Duke Energy Corporation

Subject: McGuire Nuclear Station, Unit 2
Docket No. 50-370
Relief Request 01-001

RELIEF REQUEST NO. 01-001

McGuire Nuclear Station - Unit 2

Component ID/Weld No. 2NC2FW53-25

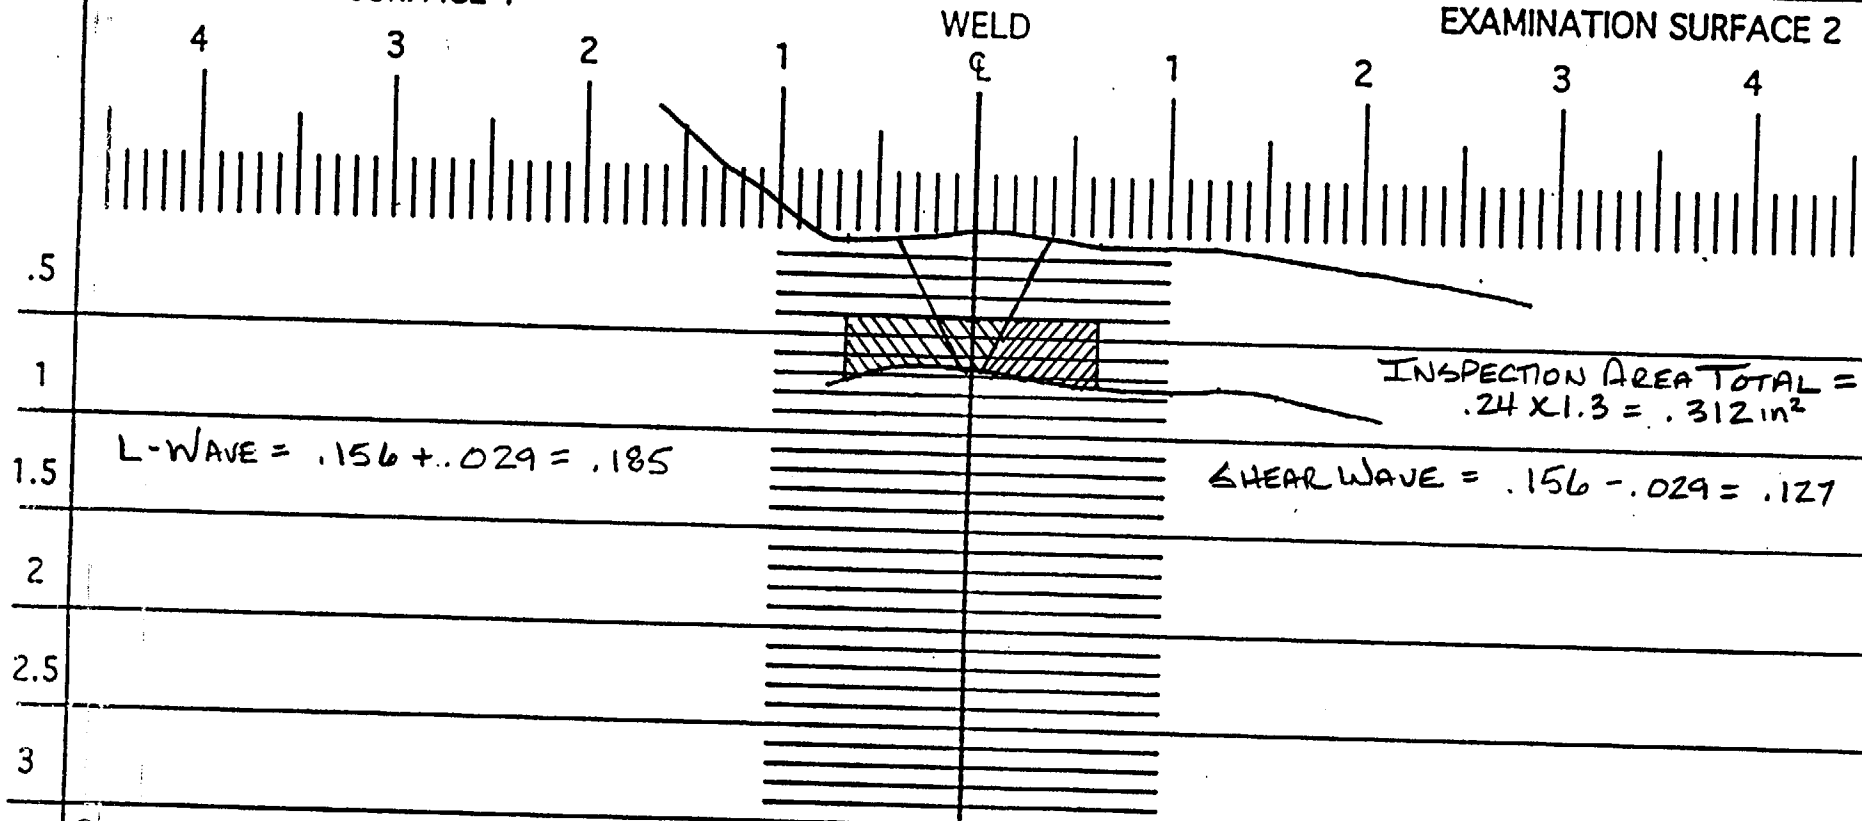
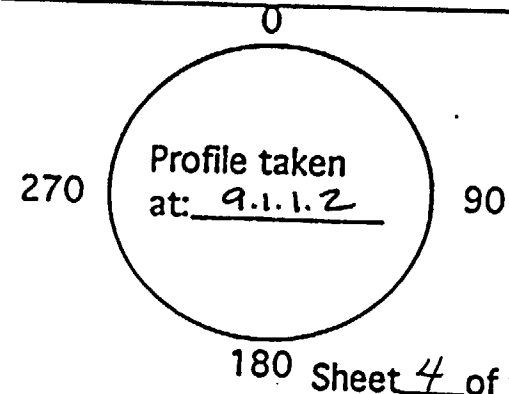
During the ultrasonic examination of Weld Numbers 2NC2FW53-25 (B09.011.032) and 2NC2FW53-37 (B09.011.039) coverage of the required examination volume could not be obtained. The examination coverage was limited to 60.30%. These are stainless steel pipe to flange welds where access is limited to the pipe side only. See Attachment 1

DUE TO FLANGE CONFIGURATION

Component ID/Weld No. 2NC2FWS3-37

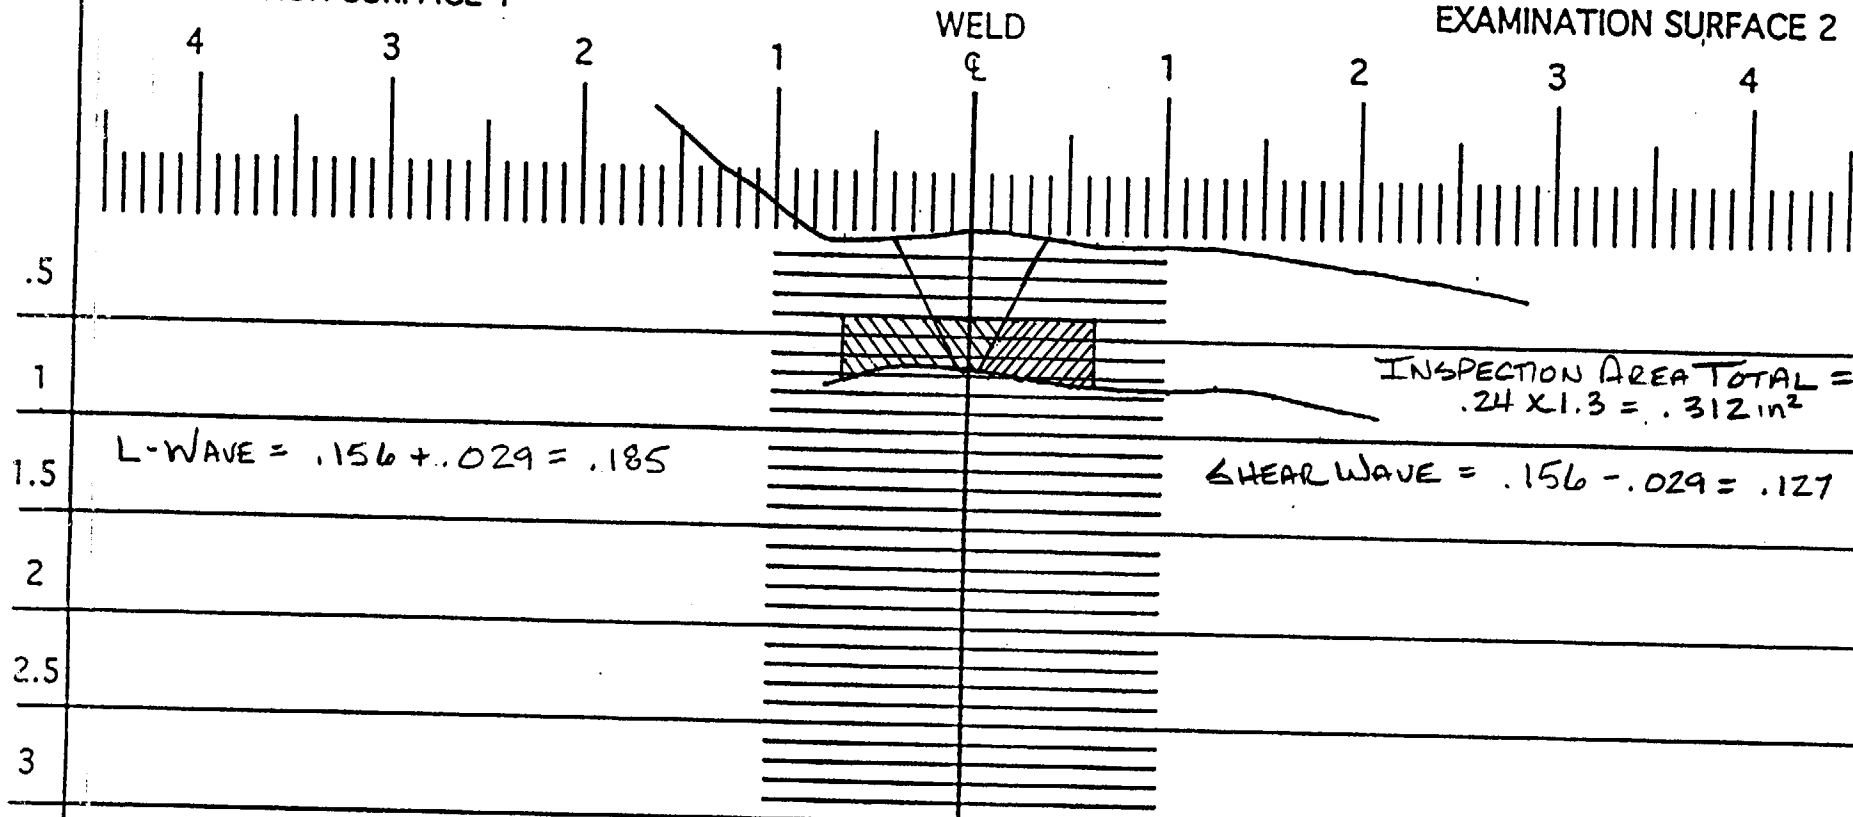
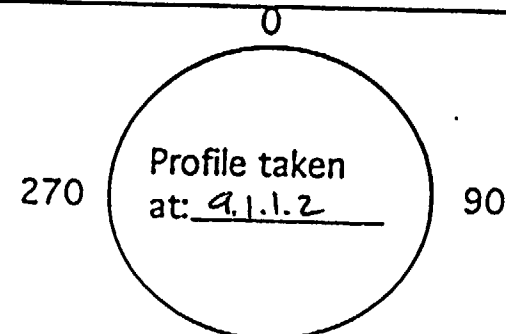
DUE TO FLANGE CONFIGURATION

2 NI 2 F 471

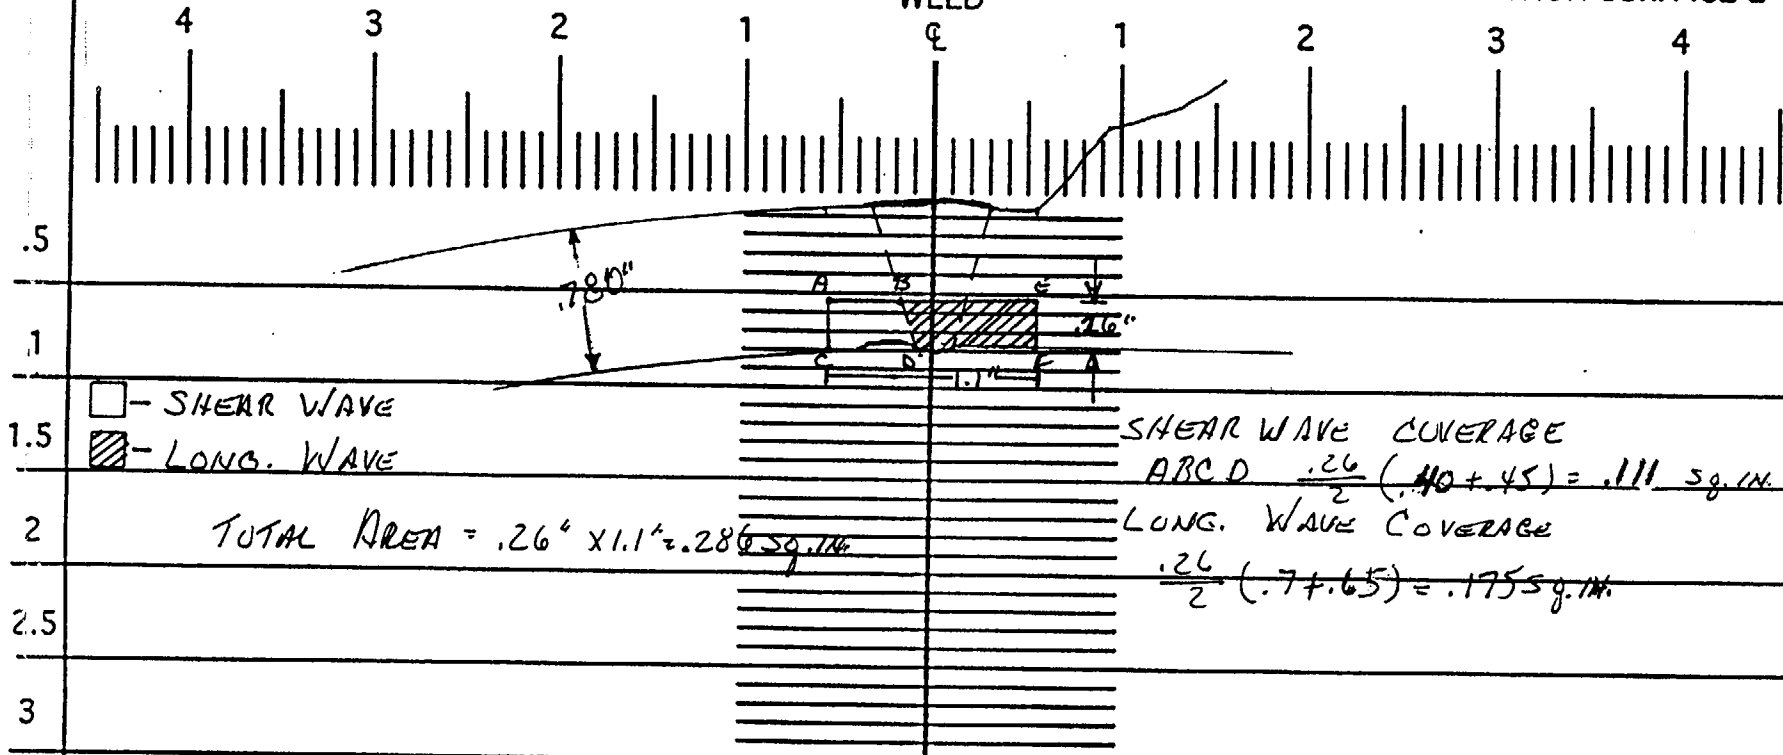
During the ultrasonic examination of Weld Numbers 2NI2F471 (B09.011.162) and 2NI2F494 (B09.011.165) coverage of the required examination volume could not be obtained. The examination coverage was limited to 59.70% and 59.61%. These are stainless steel pipe to valve welds where access is limited to the pipe side only. See Attachment 1

DUE TO VALVE CONFIGURATION

ITEM # COZ. 021.007
I.D. # ZSGC-WZ59
BY: [Signature]
DATE: 9/23/00
Pg. 7 of 9

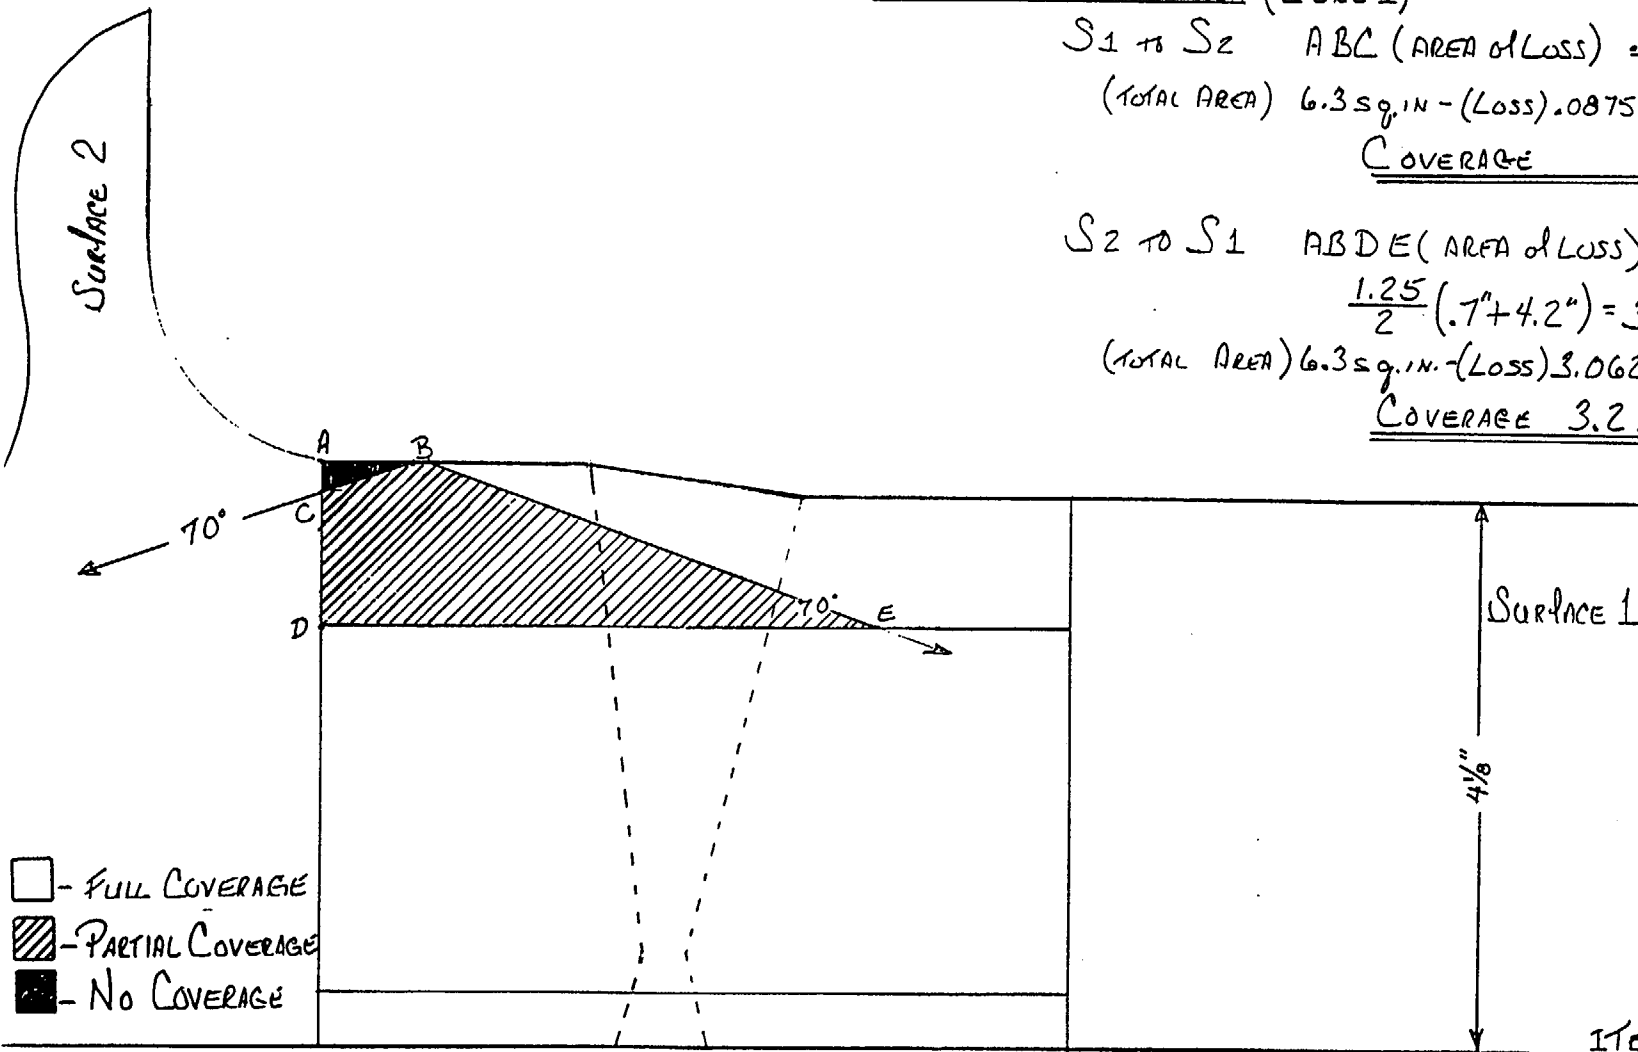
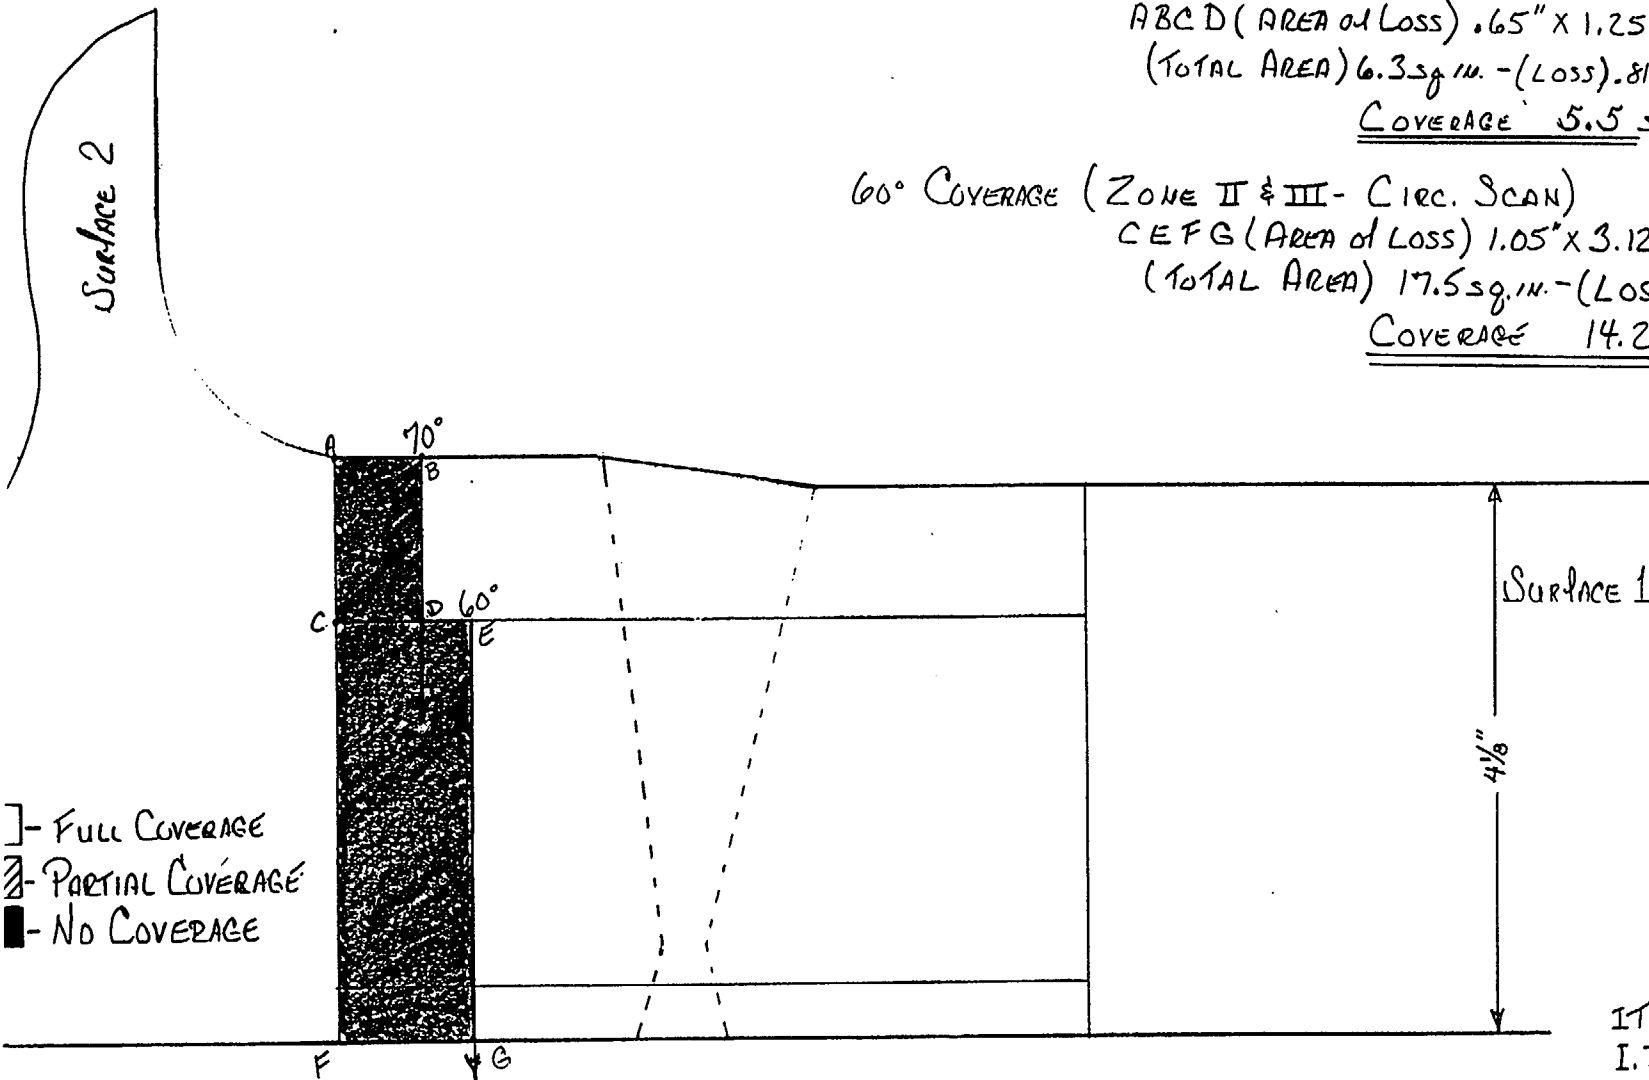
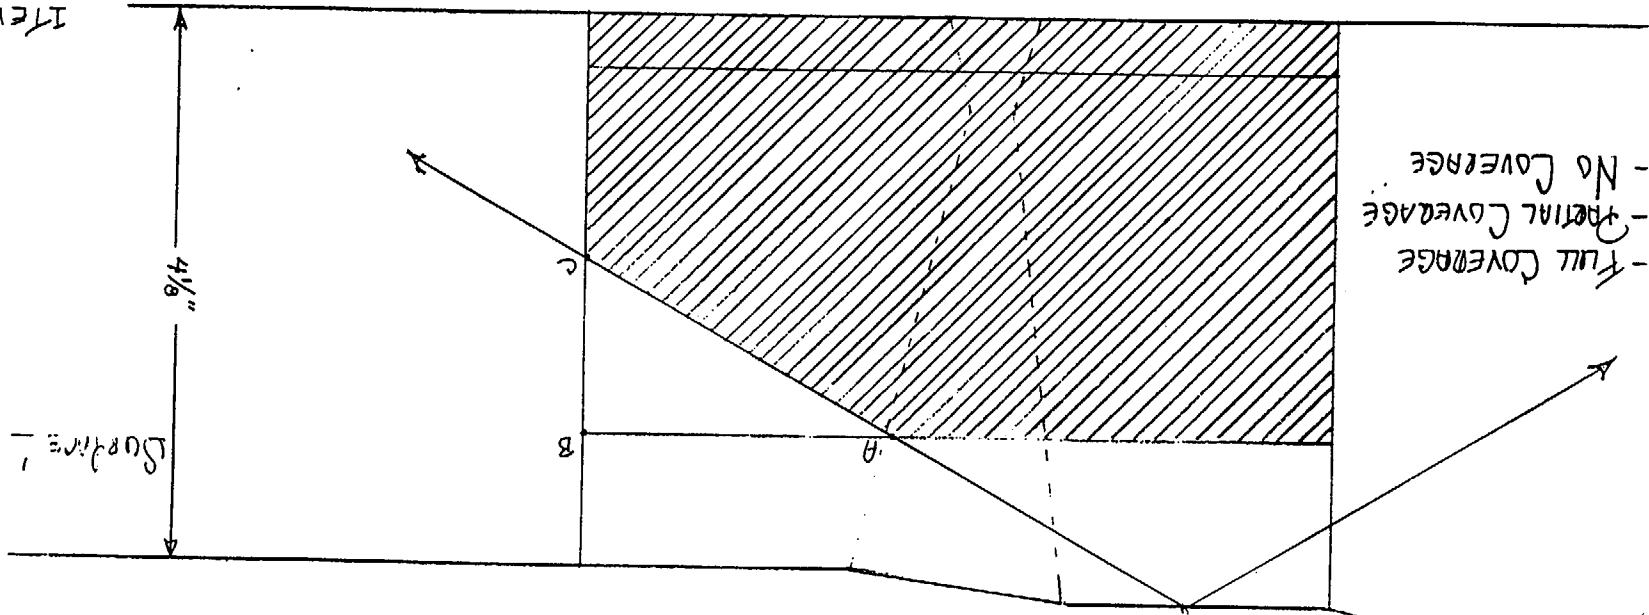
During the ultrasonic examination of the Steam Generator 2C Auxiliary Feedwater Nozzle to Shell Weld 2SGC-W259 (C02.021.007) coverage of the required examination volume could not be obtained. The examination coverage was limited to 74.40% of the required volume from one side. This is a ferritic nozzle to shell weld where access is limited to the vessel shell side only. The welded component configuration would have to be re-designed to allow scanning from both sides of the weld over the required examination volume. See Attachment 2.

70° COVERAGE AREA (ZONE I)

$$S_1 \text{ to } S_2 \quad ABC \text{ (AREA OF LOSS)} \quad \frac{.7 \times .25}{2} = .0875$$
$$\text{(TOTAL AREA)} \quad 6.3 \text{ sq. in.} - (\text{LOSS}) .0875 \text{ sq. in.} = 6.2125 =$$
$$\underline{\underline{\text{COVERAGE} \quad 6.2 \text{ sq. in.}}}$$

S2 TO S1 ABDE (AREA OF LOSS)

$$\frac{1.25}{2} (.7 + 4.2) = 3.0625$$
$$\text{(TOTAL AREA)} \quad 6.3 \text{ sq. in.} - (\text{LOSS}) 3.0625 = 3.2375$$
$$\underline{\underline{\text{COVERAGE} \quad 3.2 \text{ sq. in.}}}$$

Item # C05.011.129
Weld # 2N12F493

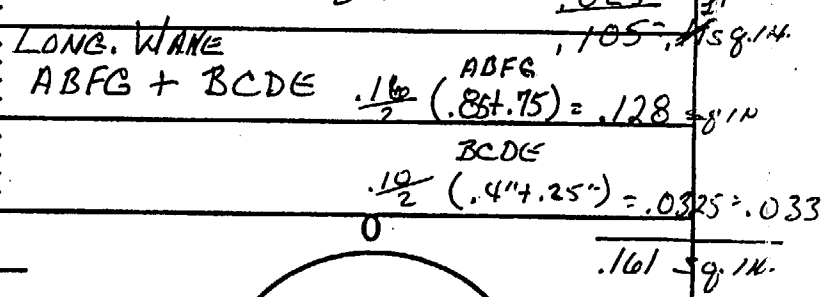
During the ultrasonic examination of the Safety Injection System Circumferential Weld 2NI2F493 (C05.011.129) coverage of the required examination volume could not be obtained. The examination coverage was limited to 59.86%. This is a stainless steel pipe to valve weld where access is limited to the pipe side only. See Attachment 3.

DUE TO VALVE CONFIGURATION
